Hyattsville Accessibility Transition Plan

University Christian Church (Ward 3 Voting Location)

6800 Adelphi Road

University Christian Church (Voting Location Ward 3) - Hyattsville Transition Plan

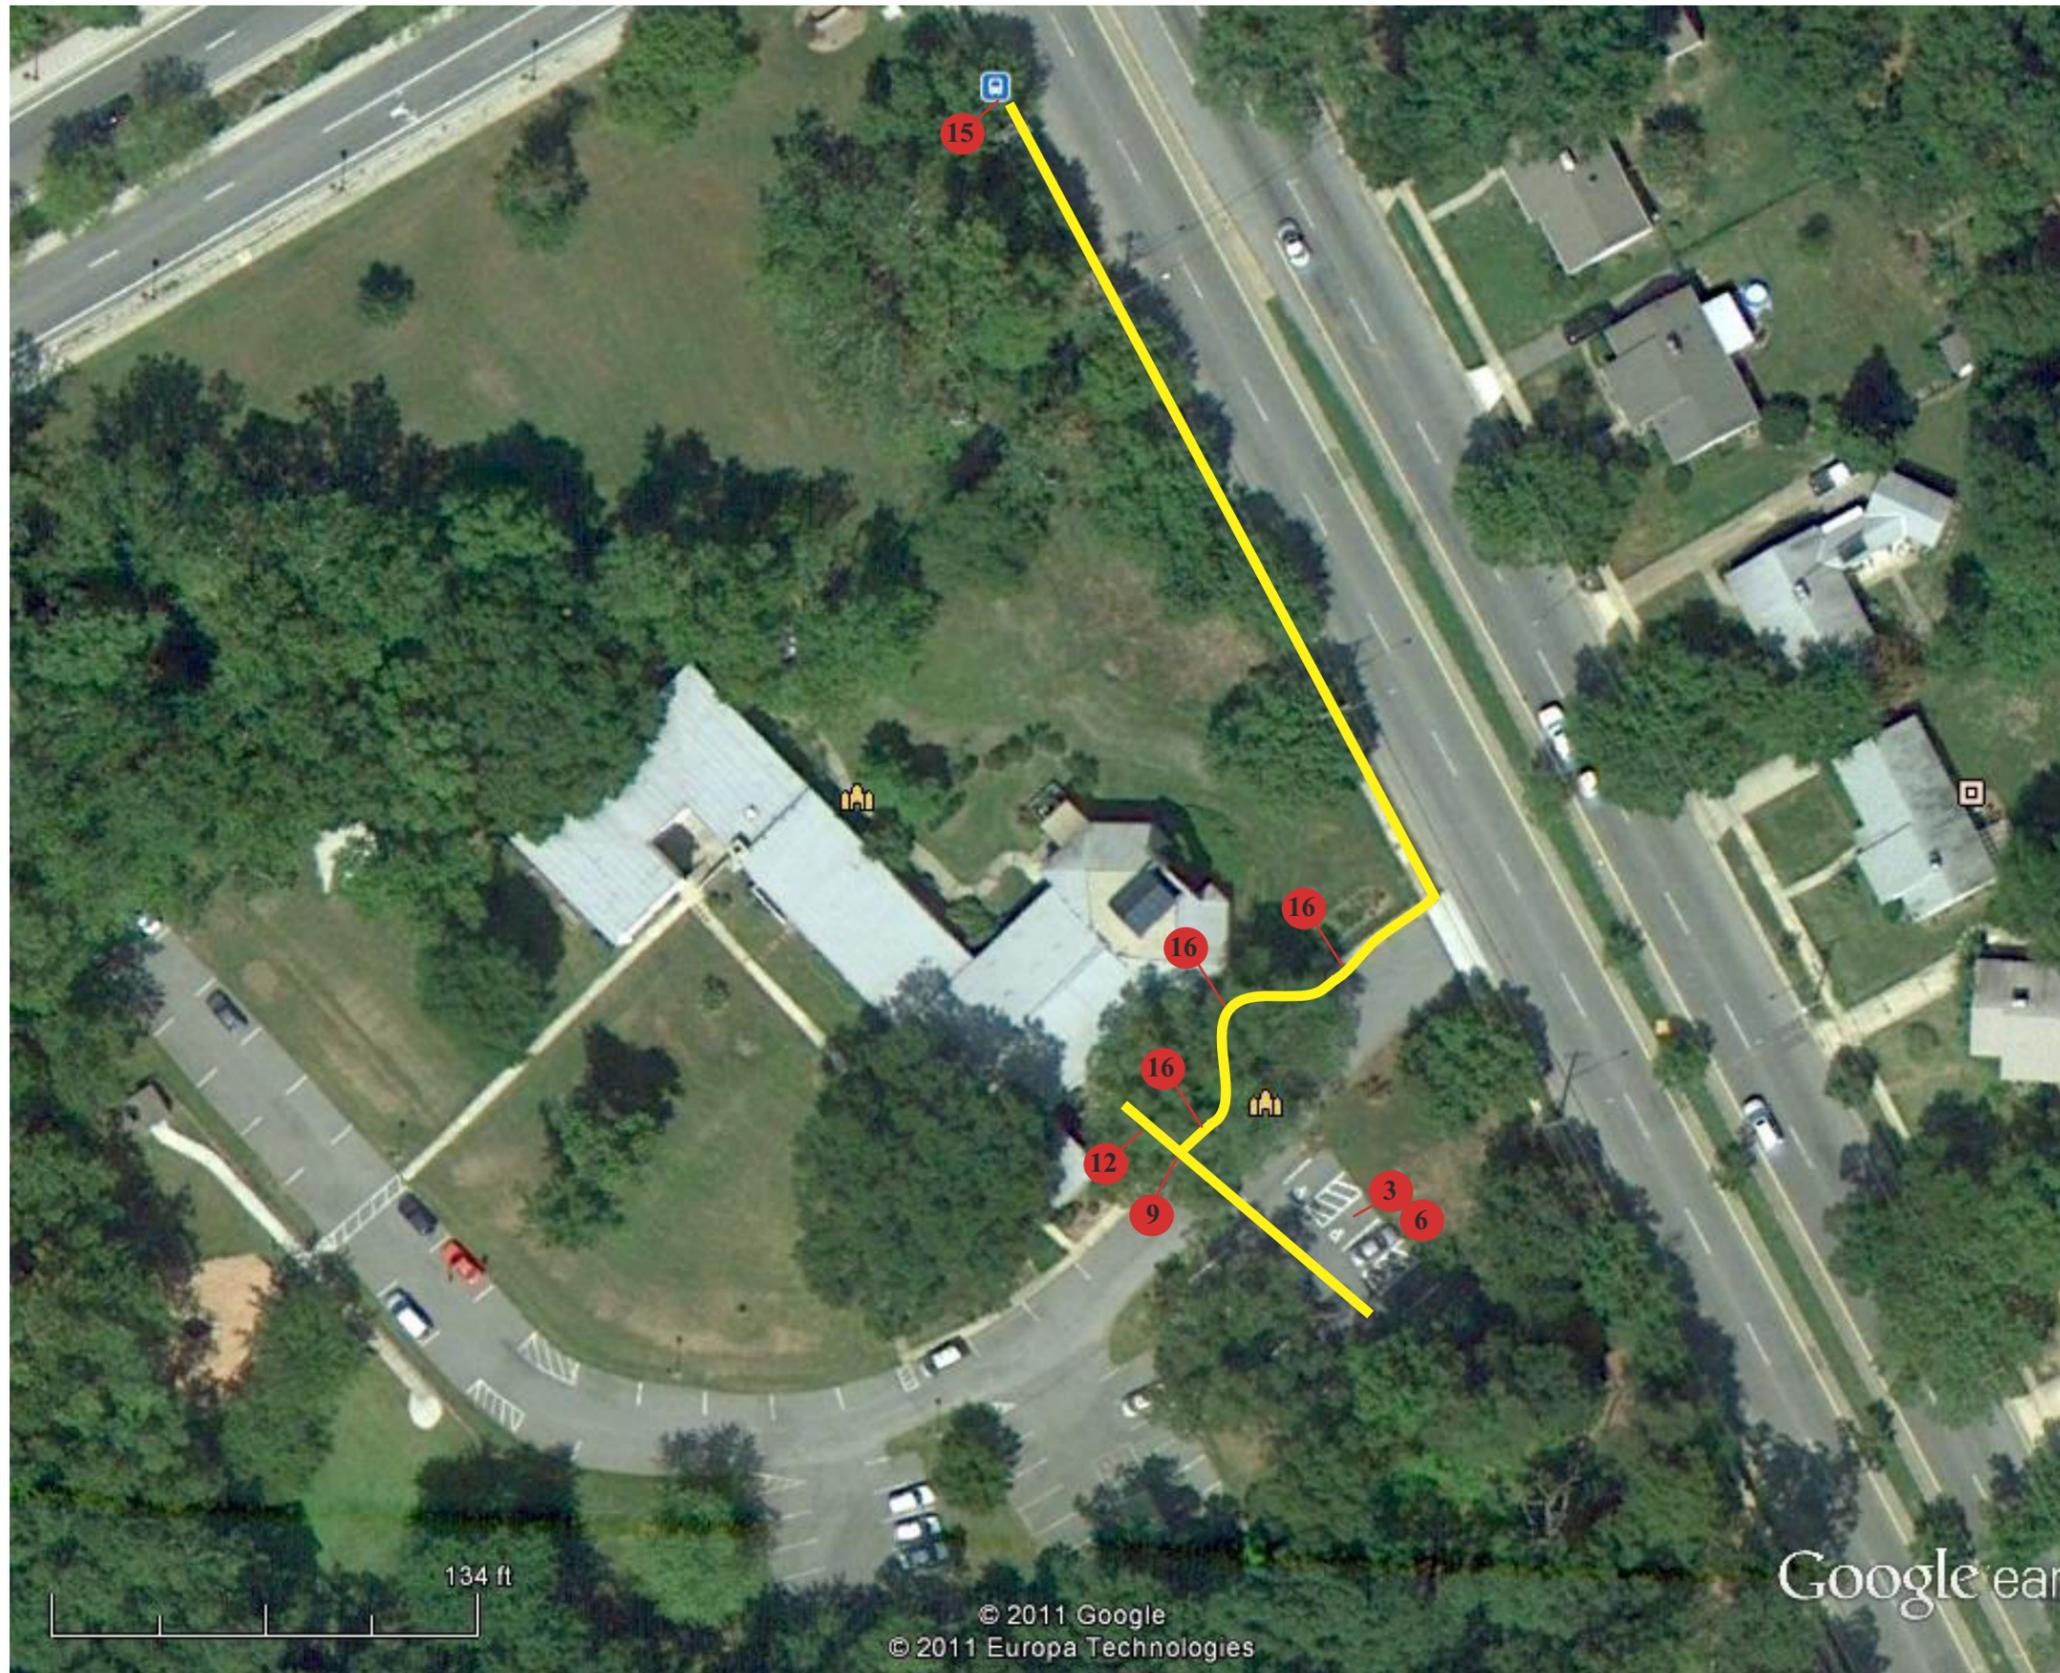
2010 Standards Citation	Description/Issue/Requirement	Non-Complying Item	Photos	Proposed Solution	Suggested Priority	Projected Cost MSHA	Projected Cost Hyattsville	Projected Cost Total	Projected Date	Action and Date
1											
2		Exterior Accessible Route from Parking Lot to Building Entry/Voting Location:									
3	208, 502.4	Parking spaces and access aisle cannot slope more than 2% in any direction.	A significant portion of the accessible parking spaces and access aisles in the parking lot have slopes or cross-slopes ranging between 3.0% and 4.5%.	2858, 2859, 2878, 2879	Overlay (5) existing accessible spaces with 2" asphalt topping installed to have slopes and cross slopes no more than 2%. When repainting parking spaces change one existing car space and aisle into a van accessible space. Van accessible spaces should be 11'-0" wide with a 5'-0" aisle, or be 8'-0" with a 8'-0" wide aisle. Provide new van space sign. Overlay asphalt with 2" topping to create an accessible route from accessible parking access aisles to the curb ramp at building entry.	1		\$8,375	\$8,375

4	*208.2.4,	At least one van accessible parking space must be provided for every 8 accessible parking spaces.	Five (5) accessible spaces are provided. Therefore, at least one (1) must be van accessible. However, no van spaces are provided.		Corrected with solution for item 3	1		see item 3	\$0		
5	208.2, 502.2, 502.3.1	An accessible parking space must have an access aisle that is at least 60" wide.	At one of the accessible parking spaces the access aisle measured centerline to centerline is 56".	2838, 2839, 2840, 2841	Corrected with solution for item 3.	1		see item 3	\$0		
6	208.2, 502.6	Accessible parking signs must be visible over parked vehicles. It is acceptable to have the bottom of the sign at least 60" above the parking surface.	At all accessible spaces, the bottom of the five accessible parking signs are between 44" and 57" above the parking surface.	2842, 2843, 2844, 2845, 2846, 2847, 2848, 2849, 2850, 2851, 2852, 2853, 2854, 2855, 2856, 2857	Remount signs above 84" level.	6		\$800	\$800

7	206.1, 403.3	Accessible route cannot have a cross slope that is more than 2%.	A significant portion of the accessible route through the parking lot has a cross slope that ranges between 3.0% and 4.2%.	2930, 2931, 2934, 2935,	Corrected with solution for item 3	1		see item3	\$0		
8	206.1, 403.3	Accessible route cannot slope more than 8.33% and cannot slope more than 5% without having ramp features.	A significant portion of the accessible route through the parking lot has a slope that ranges between 6.0% and 13.4%.	2902, 2903, 2904, 2905	Corrected with solution for item 3	1		see item3	\$0

2010 Standards Citation	Description/Issue/Requirement	Non-Complying Item	Photos	Proposed Solution	Suggested Priority	Projected Cost MSHA	Projected Cost Hyattsville	Projected Cost Total	Projected Date	Action and Date
9	206.1, 403.3	Accessible route cannot have a cross slope that is more than 2%.	At the sidewalk in front of the entry, the cross slope on the curb ramp is 4.7%.	2912, 2913	Remove existing curb ramp with flared sides. Construct new Type C curb ramp with flared sides that do not exceed 1:10, a slope no more than 8.33% and a cross slope no more than 2%. Repair a portion of the gutter to have counter slope no more than 5%.	1		\$3,850	\$3,850		
10	206.1, 406.1	Slope of curb ramp cannot exceed 8.33%.	The curb ramp at the sidewalk in front of the entry has a slope of 12.6%.	2910, 2911	Corrected with solution for item 9	1		See item 9	\$0		
11	206.1, 406.3	The built-up curb ramp has a flared side. It cannot slope more than 10%.	The accessible route on the sidewalk must cross the flared sides of the curve ramp (route is narrower than 36"). The flared sides are 12.4% and 18.3% which is greater than 1:10.	2914, 2915, 2918, 2919, 2920, 2921	Corrected with solution for item 9	1		See item 9	\$0

12	206.1, 403.3	Accessible route cannot have a cross slope that is more than 2%.	Along the exterior walkway near the entry door, the sidewalk has a cross slope that ranges between 4.2% and 5.9%.	2936, 2937, 2938, 2939	Rebuild sidewalk from curb ramp to entry door, with cross slopes no more than 2%.	1		\$3,960	\$3,960		
13	206.1, 303.4	Changes in level that are no more than 1/2" require a ramp, platform lift, or elevator.	At the building entry, along the accessible route between the sidewalk and the entry door, there is a change in level at a concrete joint, of more than 1/2", and is not ramped.	2942	Corrected with solution for item 12	1		See item 12	\$0		
14		Exterior Accessible Route from Bus Stop and Public Sidewalk to Building Entry/Voting Location :									
15	206.1, 403.3	Accessible route cannot have a cross slope that is more than 2%.	At the bus stop on Adelphi Road the sidewalk has a cross slope of 3.0%.	2980, 2981	Corrections are the responsibility of Maryland State Highway Administration (MSHA). Regrade and construct new concrete platform at bus stop with a maximum cross slope of 2%.	3	\$660		\$660

16	206.1, 403.3	Accessible route cannot have a cross slope that is more than 2%. Where the accessible route turns the cross slope is measured in two directions.	The accessible route between Adelphi Road and the building entry door has cross slopes between 8.1 and 8.5%.	2953, 2954, 2259, 2960	Regrade and reconstruct sidewalk with cross slopes no more than 2% and slopes no more than 5%.	1		\$4,840	\$4,840		
17	206.1, 403.3	Accessible route cannot slope more than 8.33% and cannot slope more than 5% without having ramp features.	The accessible route between Adelphi Road and the building entry door has a slope of 10% and does not have handrails.	2961, 2962	Corrected with solution for item 16	1		see item 16	\$0

2010 Standards Citation	Description/Issue/Requirement	Non-Complying Item	Photos	Proposed Solution	Suggested Priority	Projected Cost MSHA	Projected Cost Hyattsville	Projected Cost Total	Projected Date	Action and Date
18	206.1, 403.3	Accessible route cannot have a cross slope that is more than 2%. Where the accessible route turns the cross slope is measured in two directions.	At the front sidewalk leading to Adelphi Road, where the accessible route turns into the sidewalk around the tree, the cross slope is 3.8%.	2970, 2971	Corrected with solution for item 16	1		see item 16	\$0		
19	206.1, 303.4	Changes in level that are no more than 1/2" require a ramp, platform lift, or elevator.	Along the accessible route between the Adelphi Road and the entry door, there are changes in level at the concrete joints, of more than 1/2", that are not ramped.	2965, 2967, 2970, 2975	Corrected with solution for item 16	1		see item 16	\$0
